CITY OF AUSTIN
Board of Adjustment/Sign Review Board
Decision Sheet

CASE NUMBER: C15-2012-0118

ADDRESS: 1188 COLETO ST

VARIANCE REQUESTED: The applicant has requested a variance to decrease the minimum front street setback requirement of Section 25-2-492 (D) from 25 feet to 2 feet in order to erect a detached carport for a single-family residence in an "SF-3-NP", Family Residence – Neighborhood Plan zoning district. (Rosewood Neighborhood Plan)

11'x 17' Carport
to be built over existing driveway.

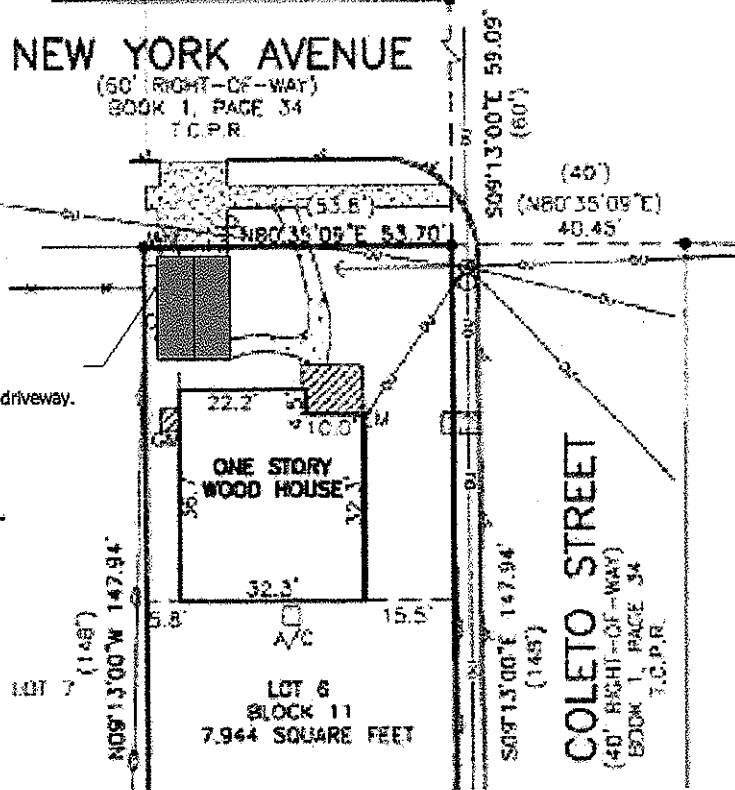
Erect a 11'x17' detached carport over the existing driveway within the 25' setback leaving a setback of 2' from the property line. The carport will clear the Austin Energy powerline buffer by > 1'.

White Line -
required clearance
from AE Line for
proposed carport

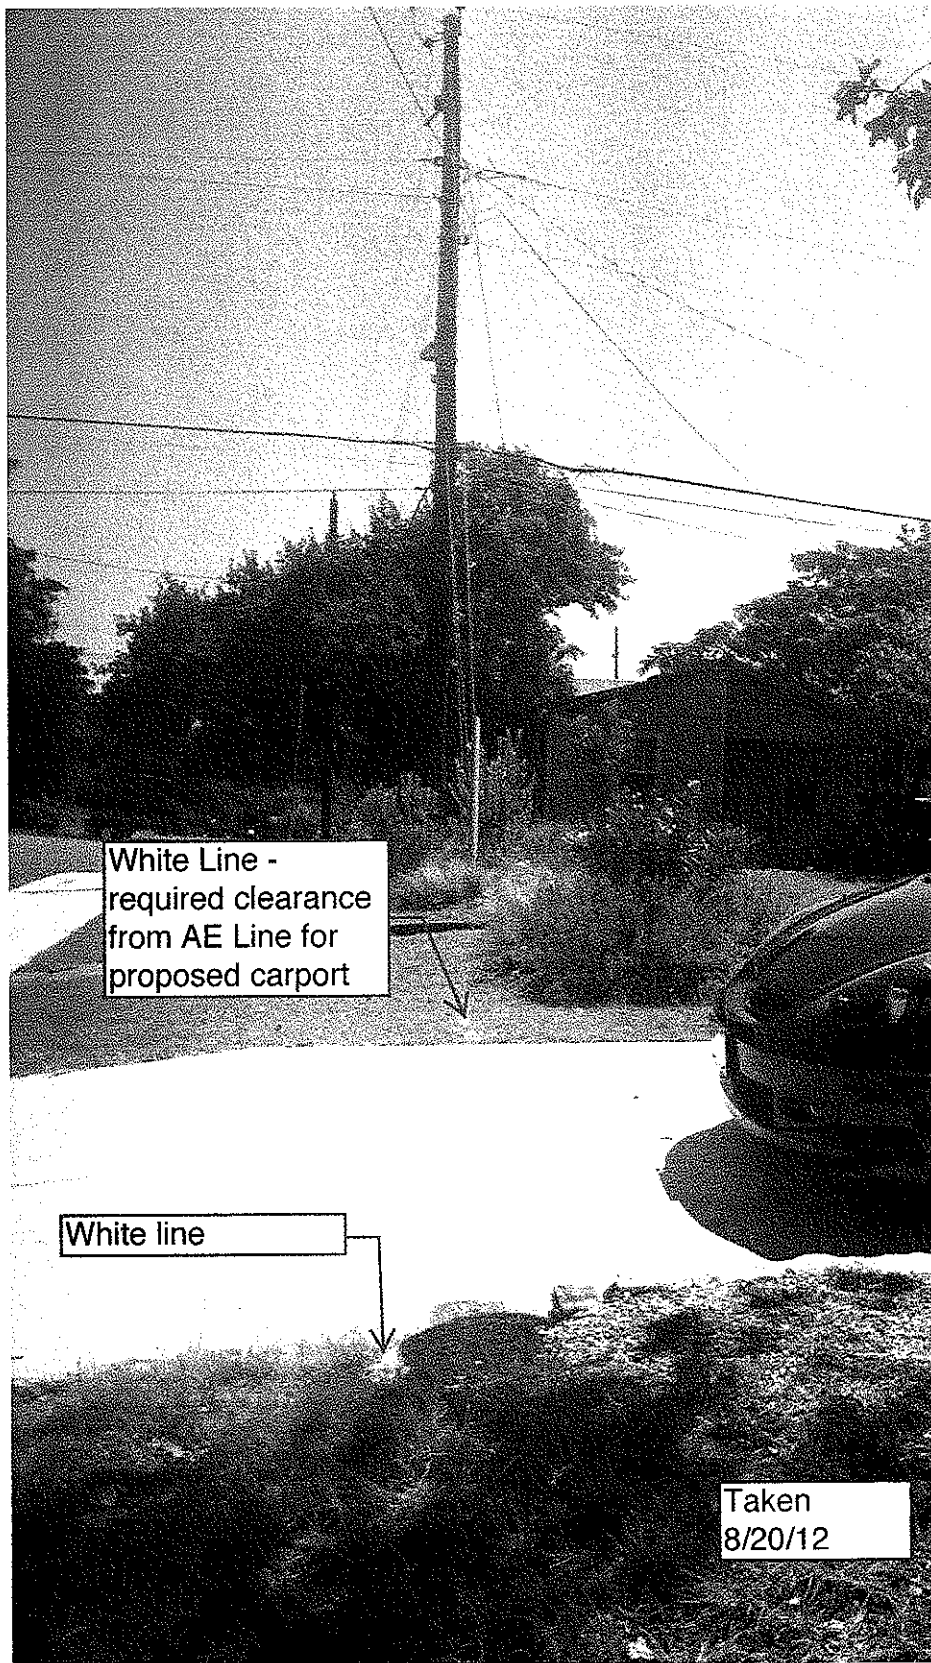
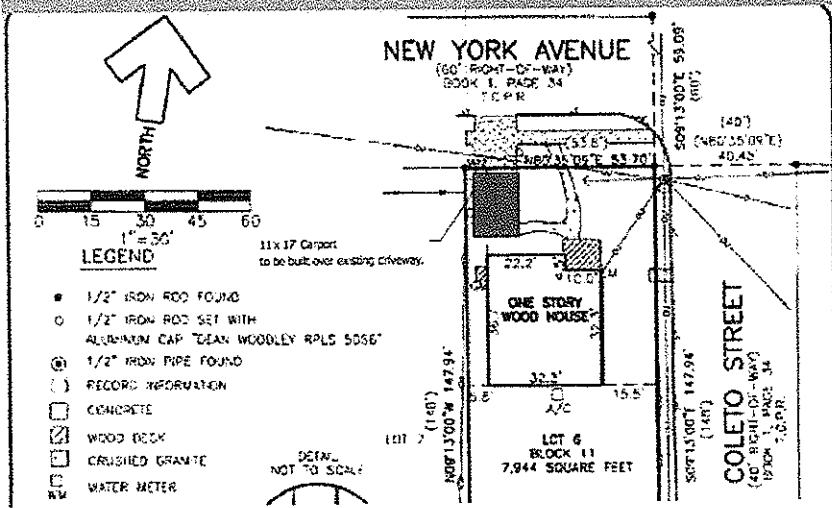
Austin Energy (AE) has reviewed your application for the above referenced property requesting to reduce the front setback from 25ft to 2ft in order to construct a carport over the existing driveway. Austin Energy does not oppose this application as requested and shown on the attached red-stamped sketch provided the future carport meets AE clearance criteria requirements as well as be in compliance with the National Electric Safety Code and OSHA. The required setback has been marked on the ground as shown and labeled in the attached photo which was taken 8/20/2012.

Austin Energy has reviewed this plan for 1188 Coleto St.
and approves the variances requested under the Board of Ad.
This plan must be approved by Austin Energy.
